Groundwater Remedy Phase 1 Construction, PG&E Topock Compressor Station, Needles, California

### PG&E TOPOCK GROUNDWATER REMEDIATION PROJECT

#### Work Variance Request #5 – Phase 1 Construction of the Remedy Produced Water Conditioning System

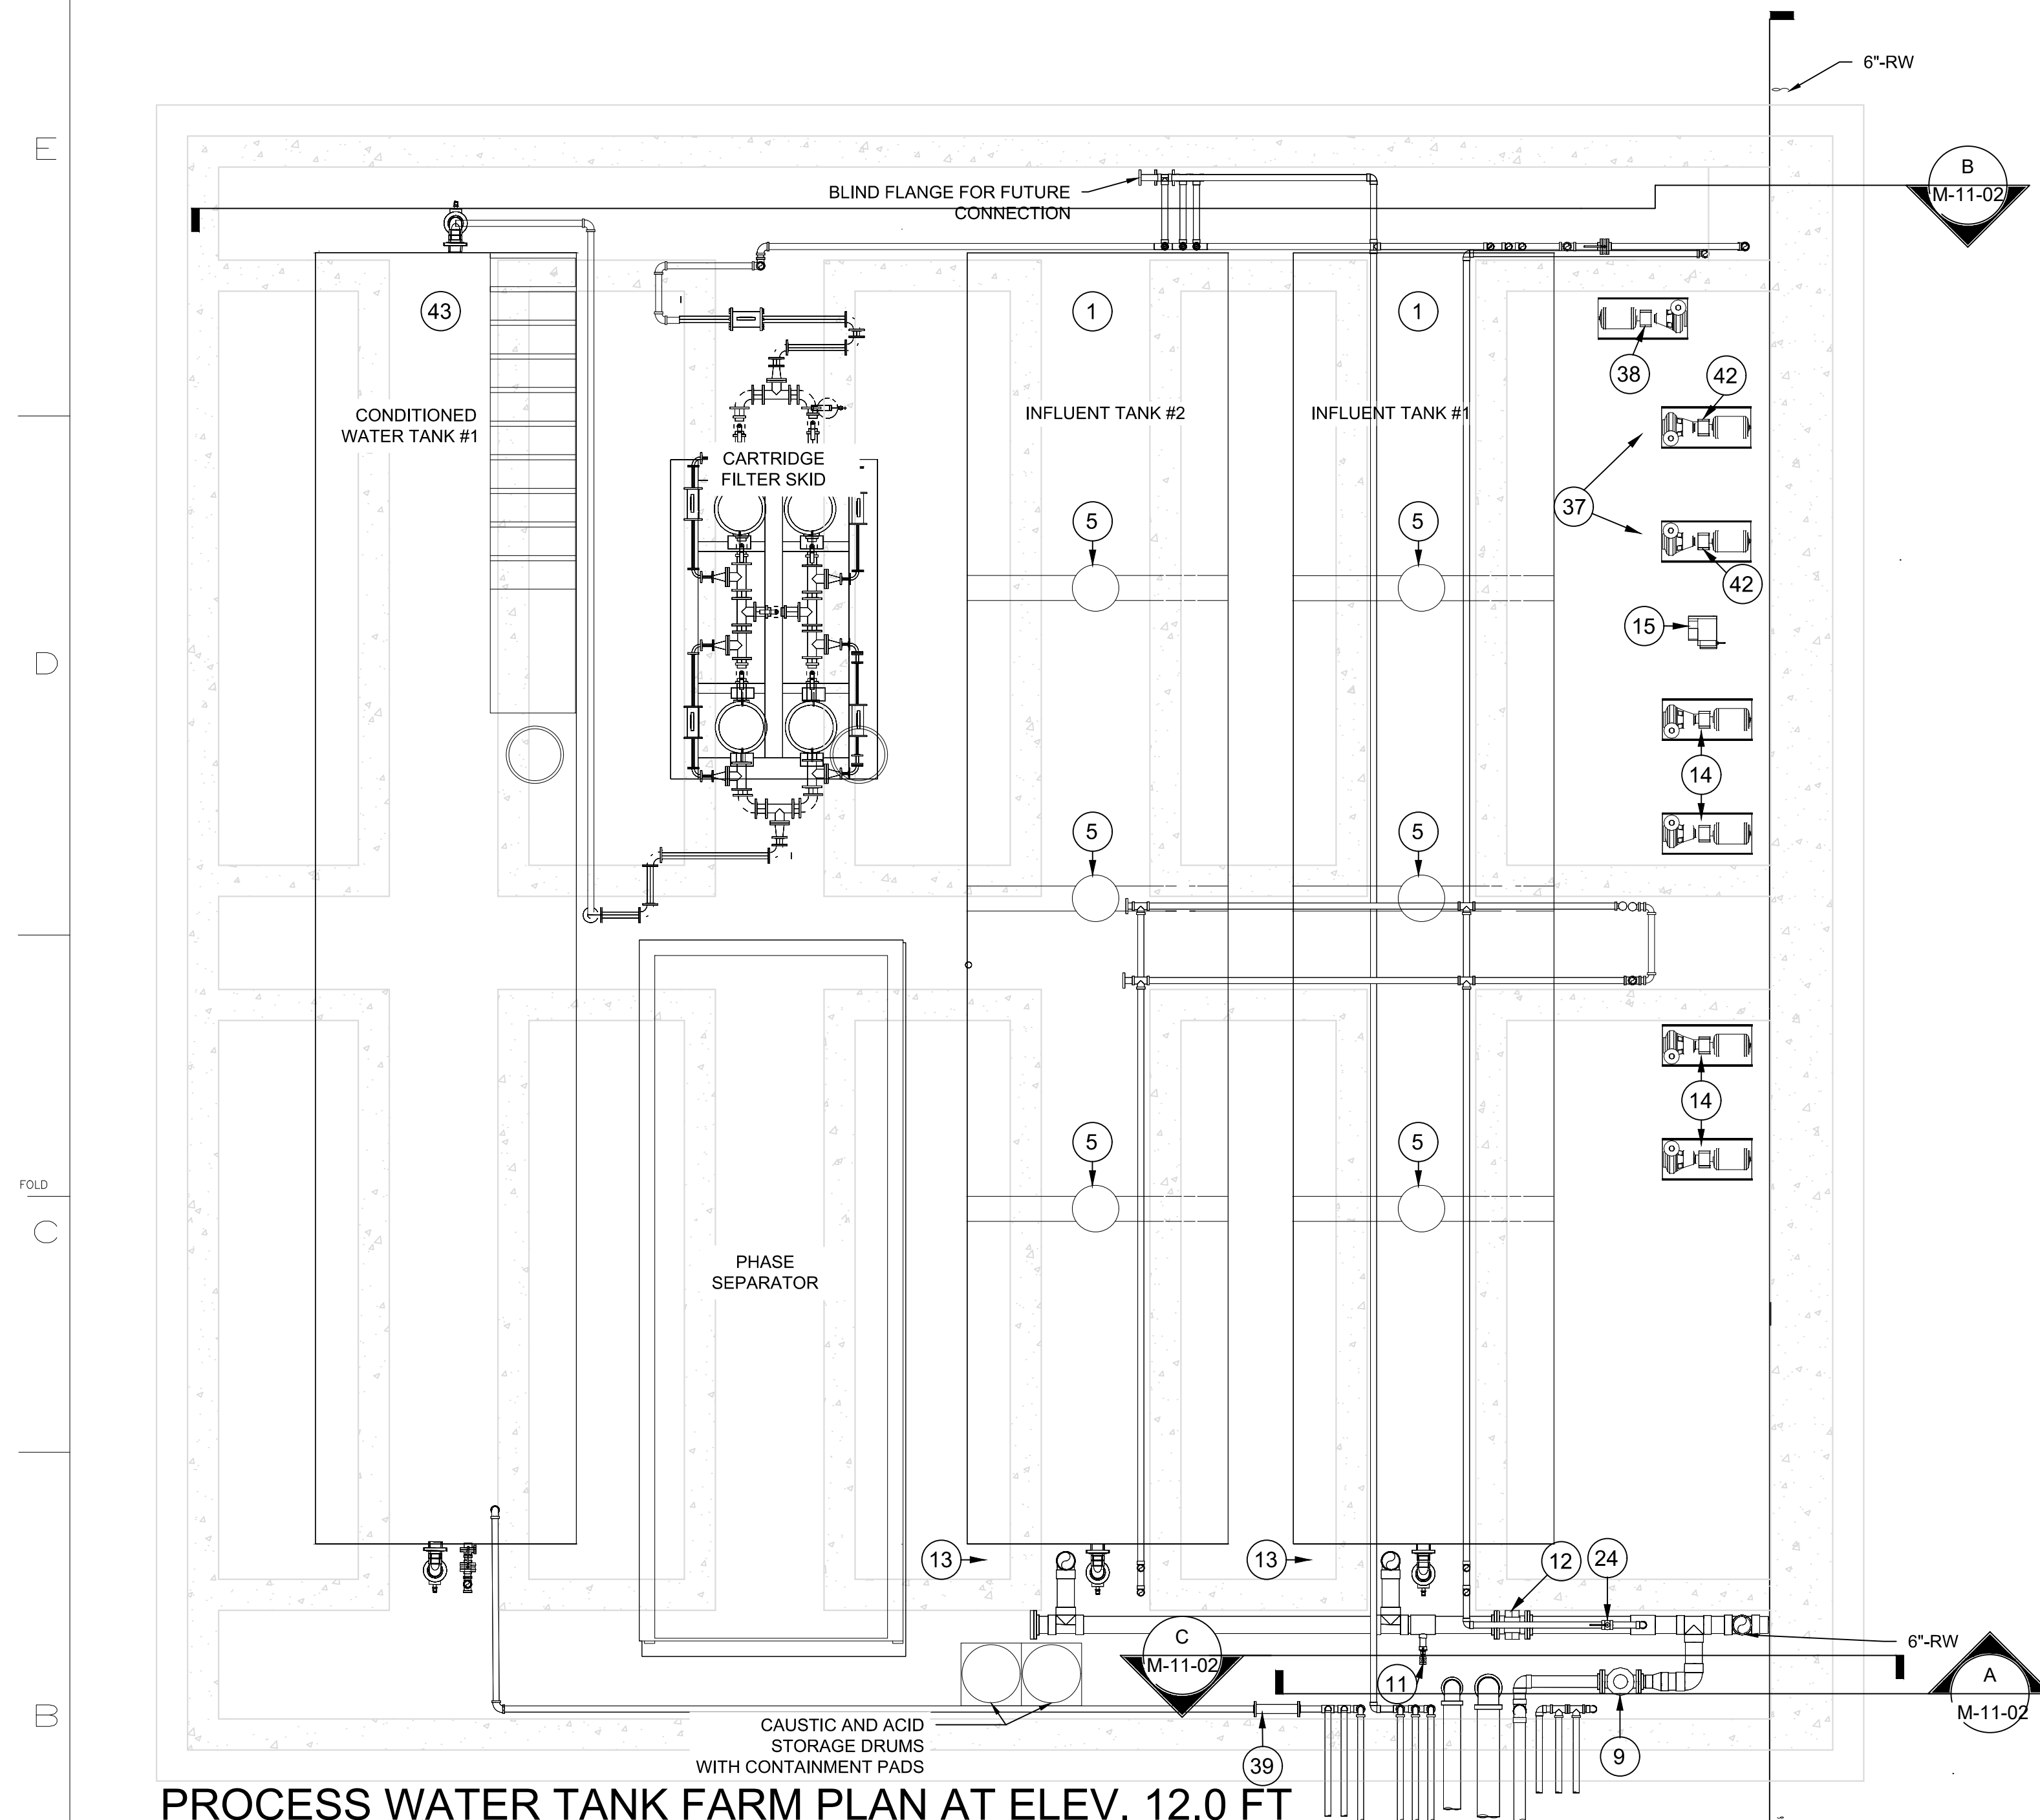
Per 100% Design Drawing #G-12-01, the RPWC system consists of four key components – an influent tank farm (i.e., four frac tanks and associated valves and pumps in a secondary containment), a remedy building, a conditioned water tank farm associated with A-side (i.e., two frac tanks in a secondary containment), and a conditioned water tank associated with B-side. The remedy building is designed to contain filtration units, phase separators, chemical containers, and associated pumps for both A-side and B-side of the RPWC system.
